CITY OF ALBUQUERQUE

**RE: Honey Well – Docks and Parking Lot
Grading and Drainage Plans
Engineer's Stamp Date: 04/05/24
Hydrology File: B17D001B**

Based upon the information provided in your submittal received 04/08/2024, the Grading & Drainage Plan **is not** approved for Building Permit and Grading Permit. The following comments need to be addressed for approval of the above referenced project:

Sheet C 2.0

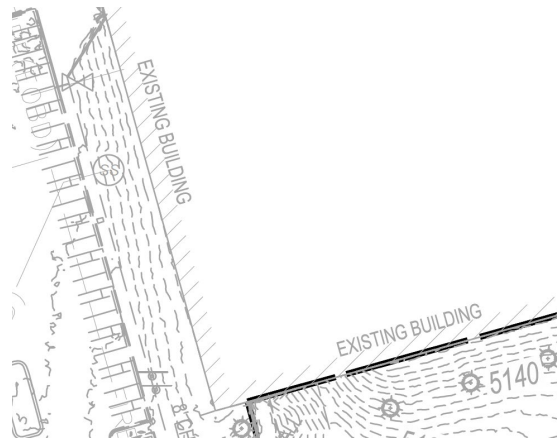
1. Please provide a Vicinity Map. This can be downloaded in pdf format from the City of Albuquerque's website.
2. Please change the title of the sheet to "Overall Grading Plan".
3. Please fix the proposed contours. As discussed, this should only be the areas where there are grading work. Since the majority of the site is not going to be touched, this should be the existing contours only.
4. There should be an index contour line which is at every 5 feet interval. The index contour line should be a little bit thicker and labeled. The minor contour lines do not need to be labeled unless it is important.
5. Please scale back the existing contours.
6. Please remove all of the architectural interior of the existing building. Instead please just show the outline of the building with a thick line with a hatch. It should look similar to the image below. **This applies to all sheets.**

Sheet C 2.1

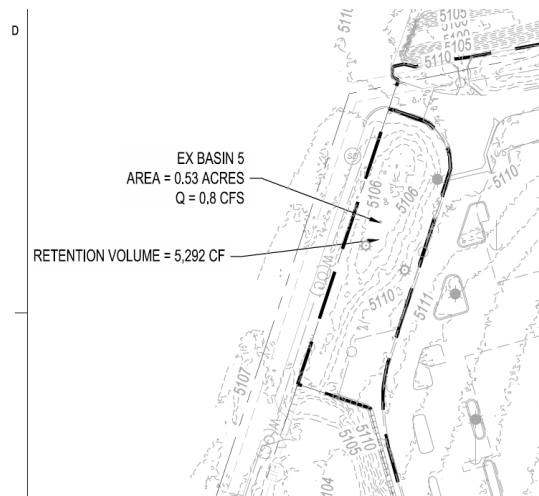
- Please type in the Existing Conditions section. This appears to just have been an image which is out of focused and hard to read.

- Please import the calculations excel sheet into AutoCAD. This appears to just have been an image which is out of focused and hard to read. It should look more like the table below.

Sheet C 2.2

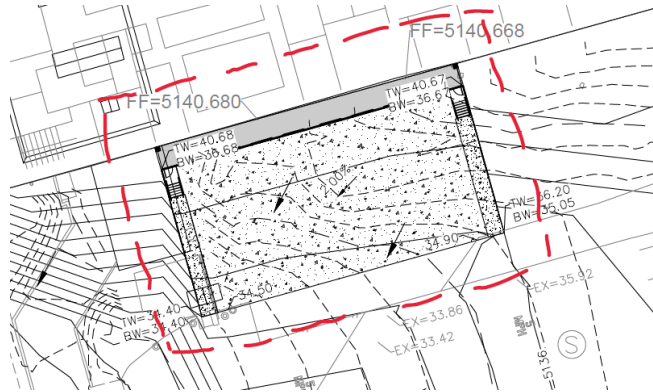
9. Please show the volumes of each of the existing retention ponds. This can be taken from the previously calculated BHI project for the same site.

10. Please show the volumes of each of the existing retention ponds and then show if any the increase required volume and if the existing retention pond has the capacity for this increase.

11. Please fix both the existing contours and proposed contours as outlined in Comment #3 above.

Sheet C 2.3

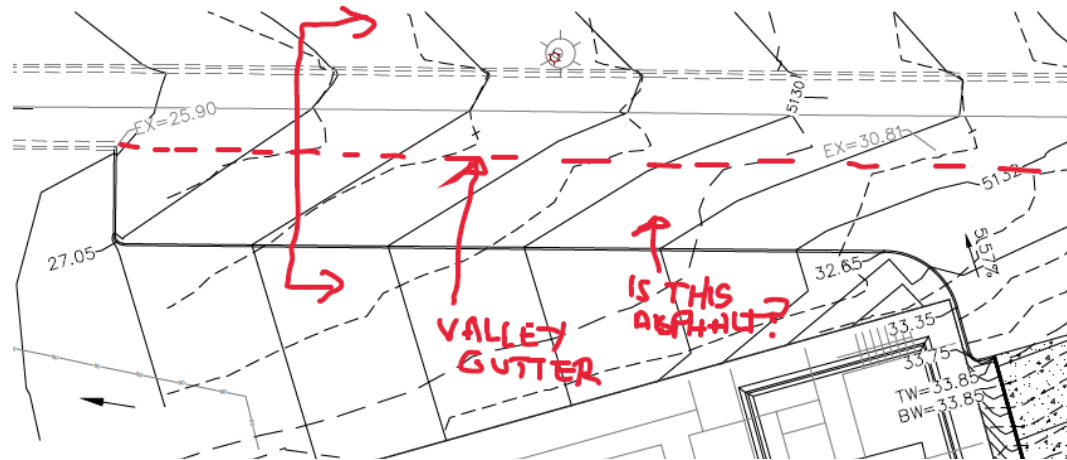
12. Please clean up the proposed dock areas. There should be no proposed elevations here. All proposed elevations need to be shown on the blow-up Detail of the dock.
13. Please place a thick dashed line around each dock and label "See Dock X Detail. This Sheet.

14. For Dock A Detail. Please provide a slope for the ramp.
15. For all Dock X Details. Please provide a Typical Sections. One showing the ramp going down to the dock and french drain and one showing the ramp going up to the dock.

16. For Dock A Detail. Please provide the pipe size going from the french drain to the slump pump.
17. For Dock A Detail. Please provide the make and model of the slump pump. Also, please provide the performance curve of the pump. Please provide a detail of the manhole for the pump with the on elevation shown.

18. For Dock A Detail. Please provide the pipe size of the discharge pipe (force main). (please not that this will be under pressure so that the correct material needs to be used.) It states that this will discharge to a concrete slab. Please provide a detail showing this. This can be incorporated into the pump manhole detail.

19. For Dock A Detail. Please provide the finished floor elevation of the building at the proposed dock. Please note that this only needs to go to the hundredths so please round up from the survey information. Also, please note that there only needs to be one number and not the two that the surveyor provided.

20. Please just show the proposed contours and tie them into the existing contours.

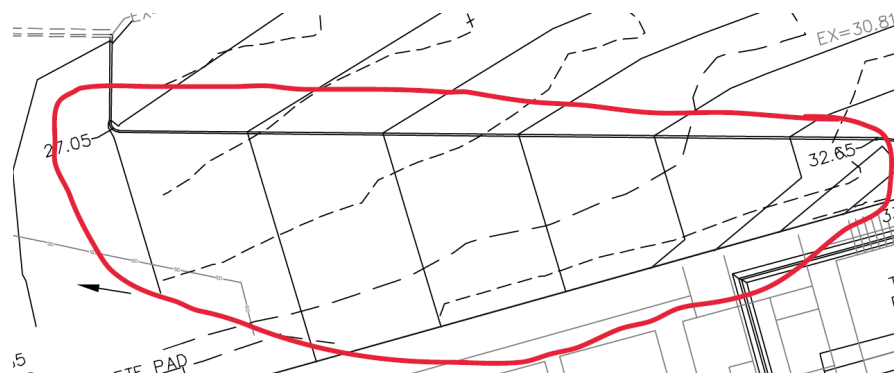
21. Please add a note "Remove the existing curb & gutter and replace with a valley gutter. This will help keep the existing drainage pattern at this location.
22. Please provide a typical section here.
23. Is the proposed pavement type asphalt? Please add a new hatch for the proposed pavement and add to the legend.
24. Please add a few new Top of Curb (TC) elevations shots for the new curbs. Also, please just tie the proposed contours to the existing contours. They don't need to go all the way to the existing building.

25. There are existing emergency doors at this location. I believe that there needs to be some sort of landing here and not just a curb. This needs to be brought up to the architect.

Sheet C 2.4

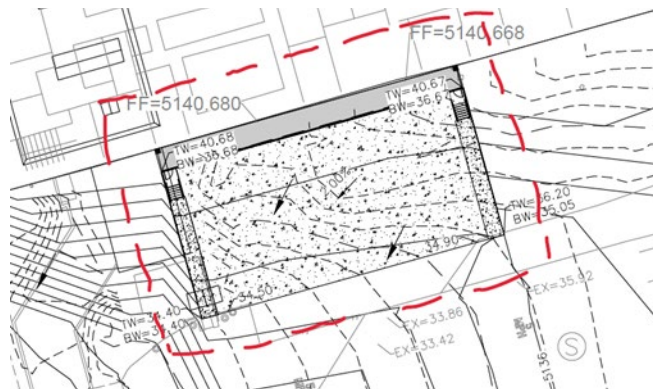
26. Please clean up the proposed dock areas. There should be no proposed elevations here. All proposed elevations need to be shown on the blow-up Detail of the dock.
27. Please place a thick dashed line around each dock and label "See Dock X Detail. This Sheet."

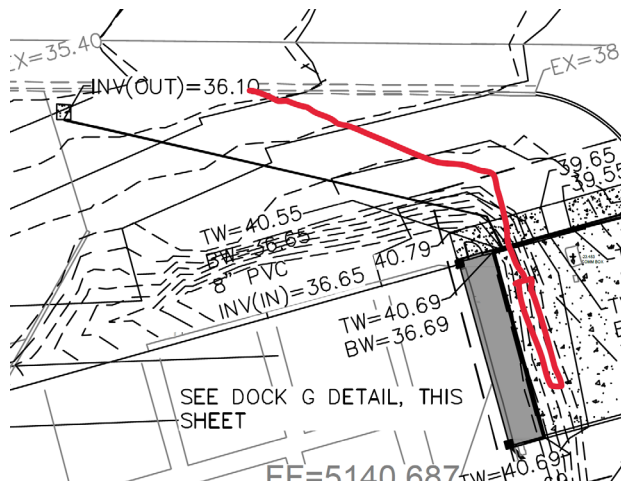
28. Dock G. There should be an inlet here like all of the other docks which goes down. The proposed pipe can then go to the back of curb in the alley where it can daylight.

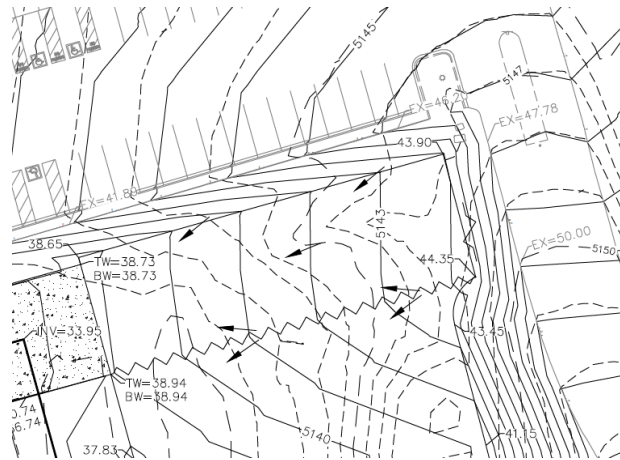
29. Again, it is hard to tell what is being constructed here. The proposed pavement disappears in all of the other line work.

30. The last dock appears to have not been designed correctly for a truck to back into. Please review this.

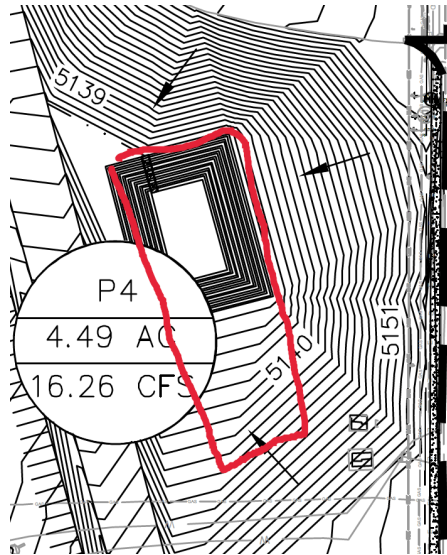
31. Please revisit the required retention pond design. I think that this could be designed a little bit better but please keep in mind to keep a side slope of 3:1 or provide a retaining wall if need be.

Sheet C 2.6

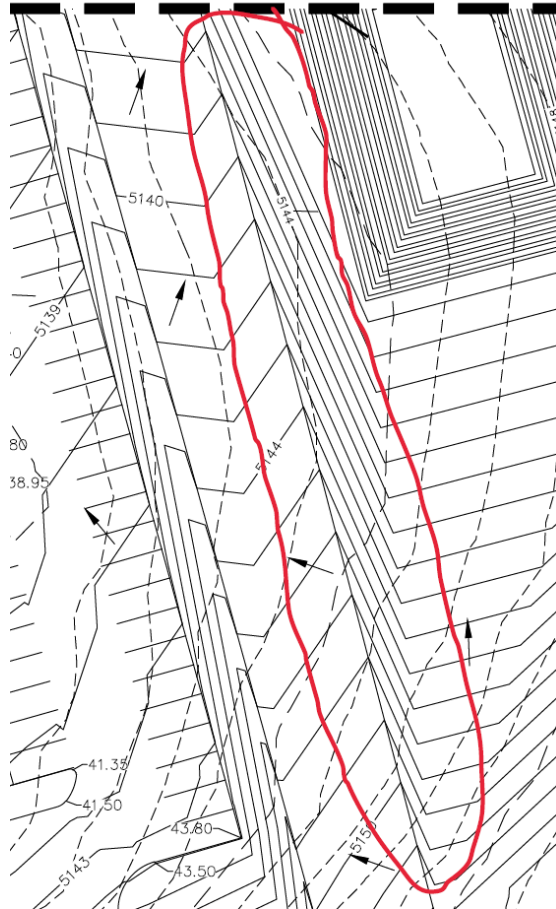
35. Please either add a curb or guardrail for the trucks in this area so that they do not roll down into the proposed retention pond.

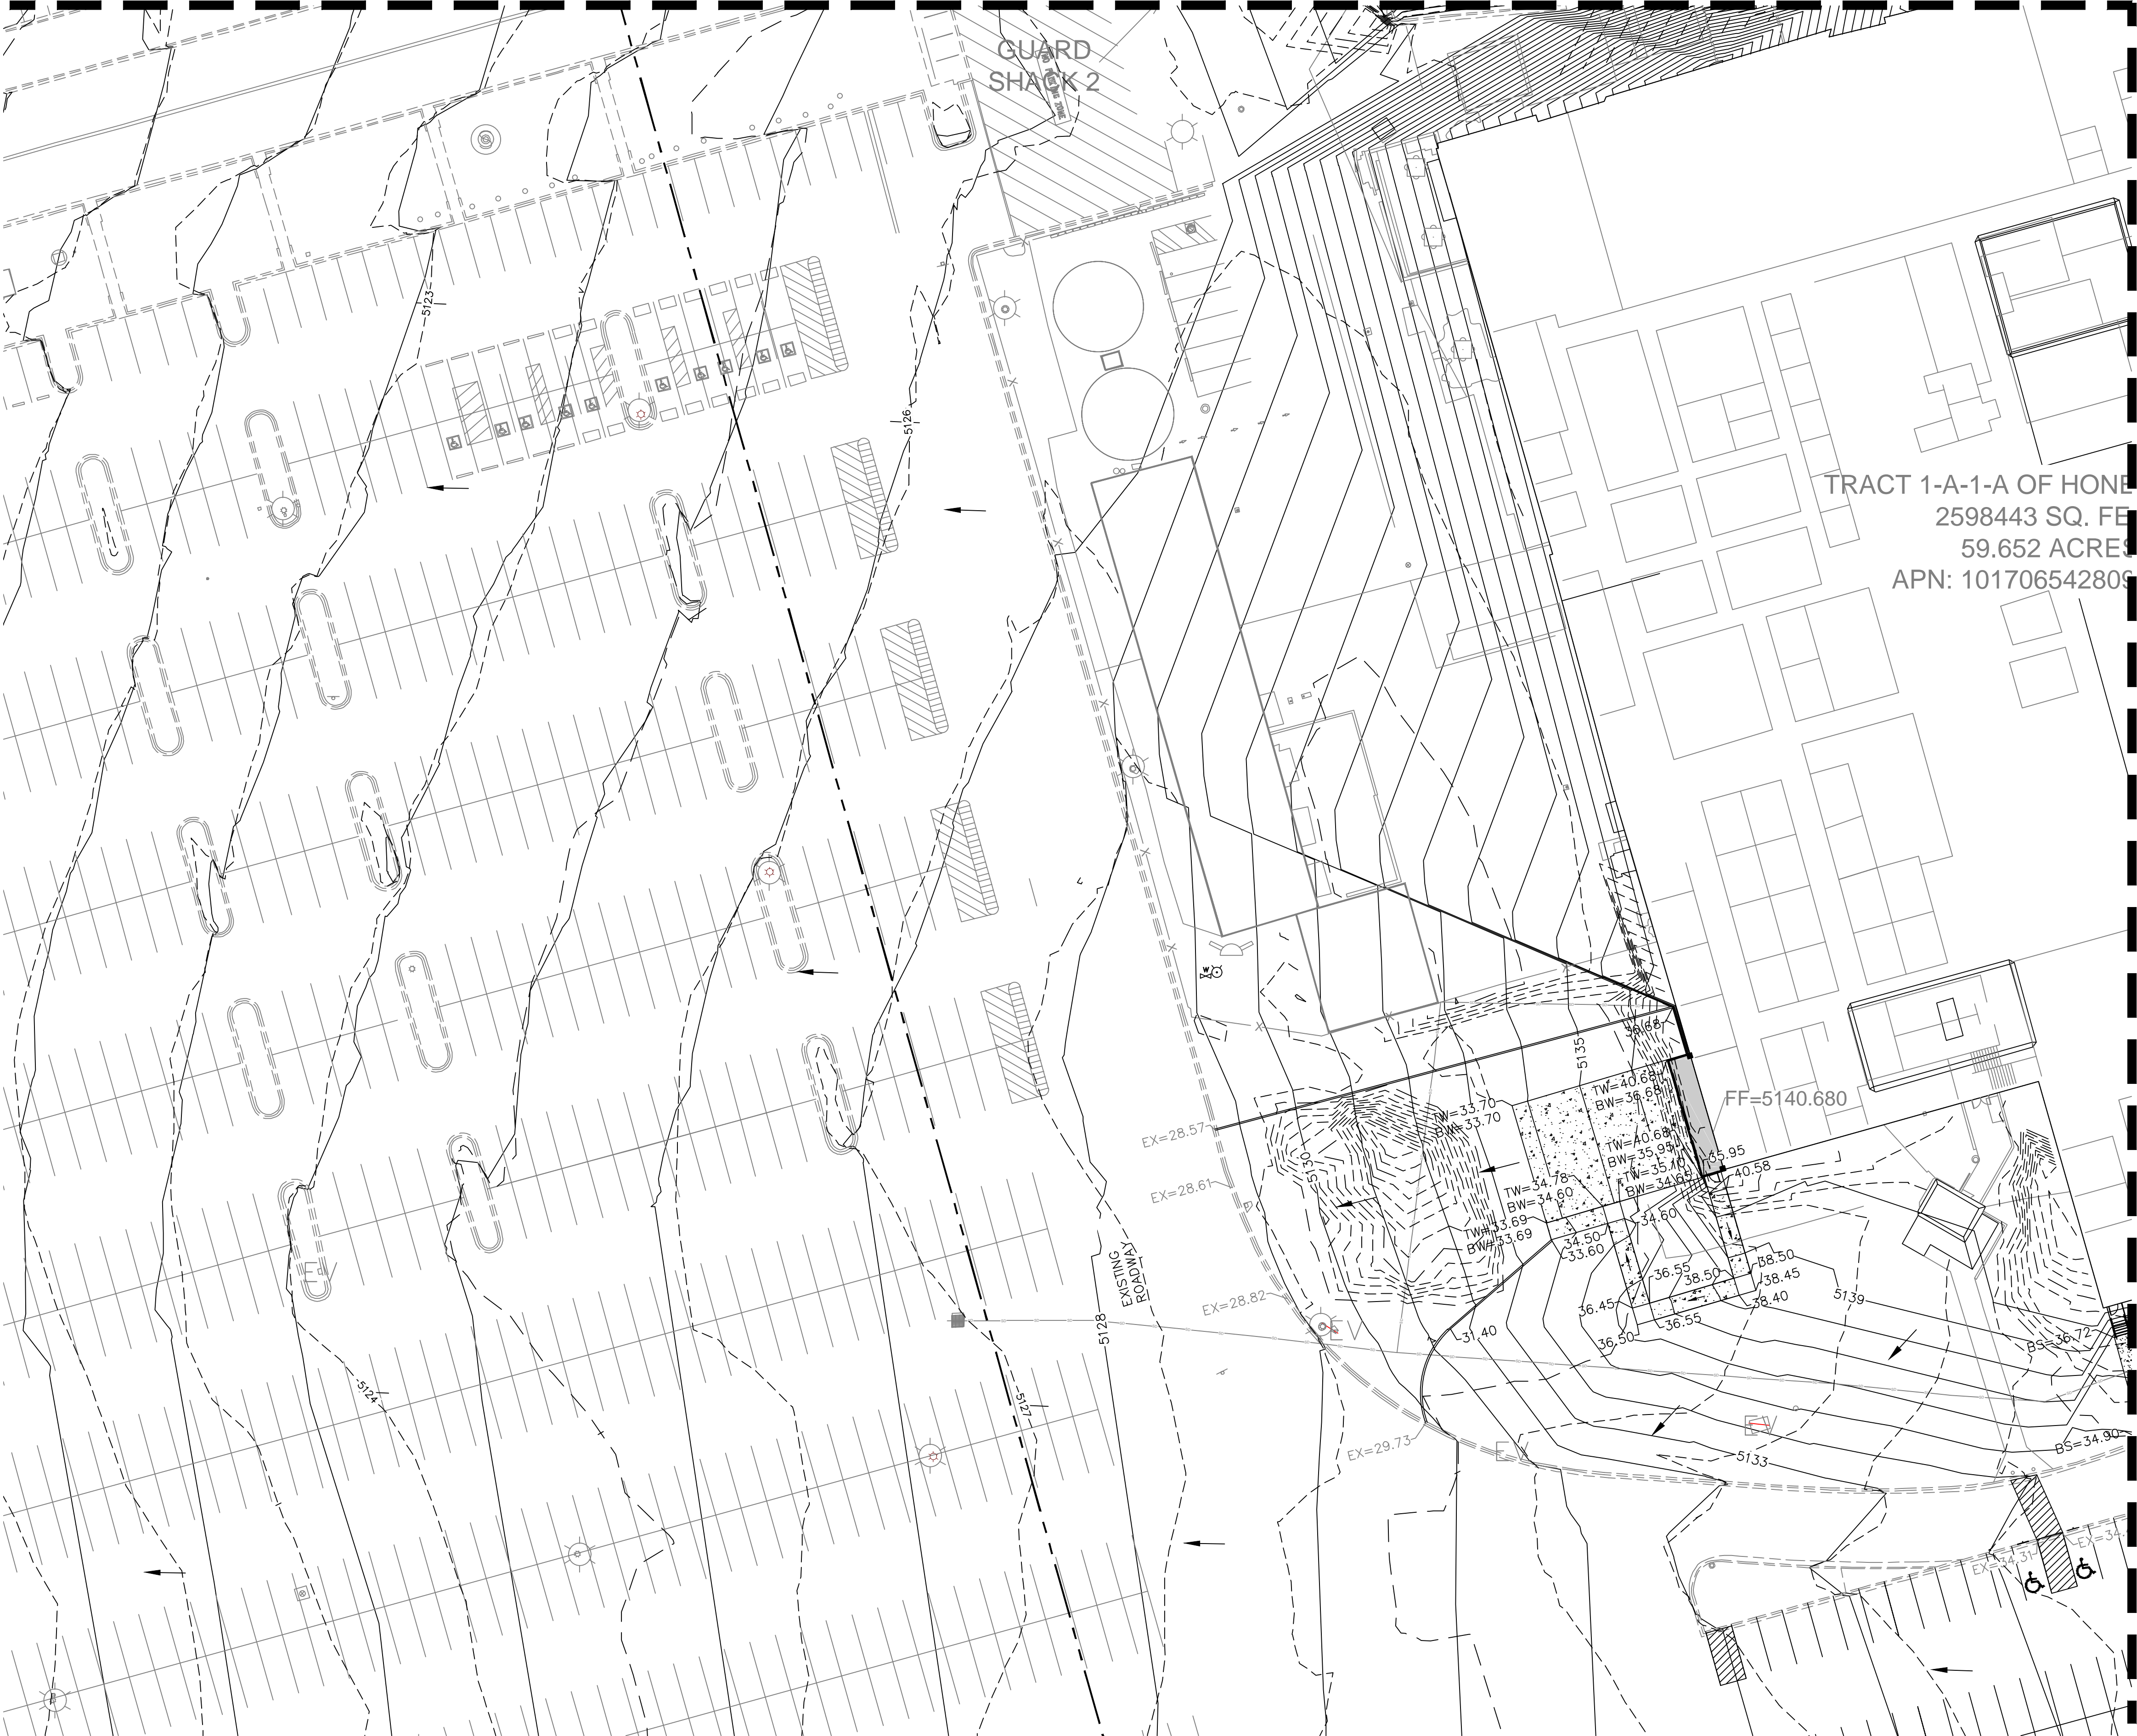
32. Please clean up the proposed dock areas. There should be no proposed elevations here. All proposed elevations need to be shown on the blow-up Detail of the dock.

33. Please place a thick dashed line around each dock and label "See Dock X Detail. This Sheet.

34. Please remove the word "Conceptual" in the sheet title.
